ITEM: 6.8	COMMITTEE OF ADJUSTMENT REPORT SUMMARY MINOR VARIANCE APPLICATION FILE NUMBER A053/23 16 WOODLAND TRAIL COURT, WOODBRIDGE
-----------	--

**COMMITTEE OF ADJUSTMENT REPORT
MINOR VARIANCE APPLICATION
A053/23
16 WOODLAND TRAIL COURT, WOODBRIDGE**

ITEM NUMBER: 6.8	CITY WARD #: 2
APPLICANT:	Caterina Nappi & Vincenzo Imperato
AGENT:	Bancheri Bros
PROPERTY:	16 Woodland Trail Court, Woodbridge
ZONING DESIGNATION:	See Below
VAUGHAN OFFICIAL PLAN (2010) DESIGNATION:	Vaughan Official Plan 2010 ('VOP 2010'): "Low-Rise Residential"
RELATED DEVELOPMENT APPLICATIONS:	None
PURPOSE OF APPLICATION:	Relief from the Zoning By-law is being requested to permit an existing swimming pool.

16 WOODLAND TRAIL

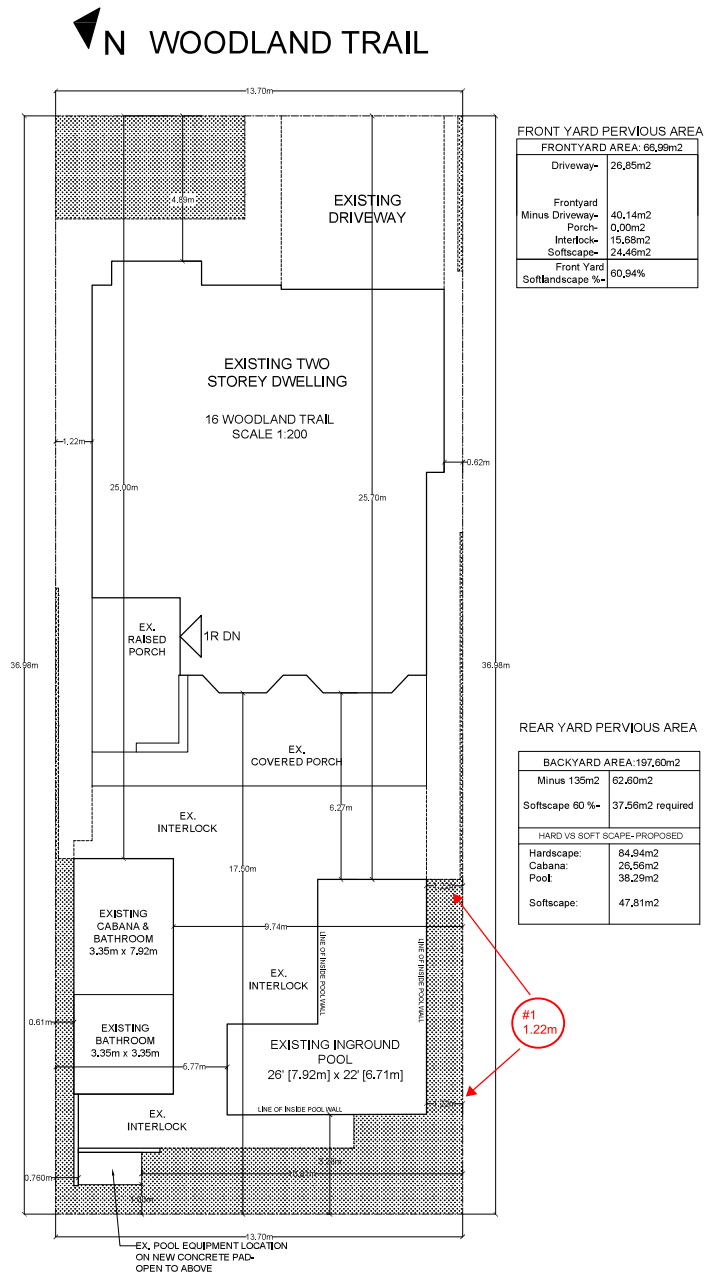
#	Zoning By-law 001-2021	Variance requested
1	The minimum setback of an outdoor swimming pool to any lot line shall be 1.5m.	To permit the minimum setback of the outdoor swimming pool to be 1.22m from the interior side lot line.

The Owners are requesting relief to permit the existing inground pool with the above-noted variance.

The Development Planning Department has no objection to the proposed variance for the pool as the reduction to the interior side yard setback is minor in nature and not anticipated to be perceptible. The pool also complies with the rear yard setback requirements in the Zoning By-law and maintains an appropriate area for safe access and maintenance.

The Development Planning Department recommends approval of the application.
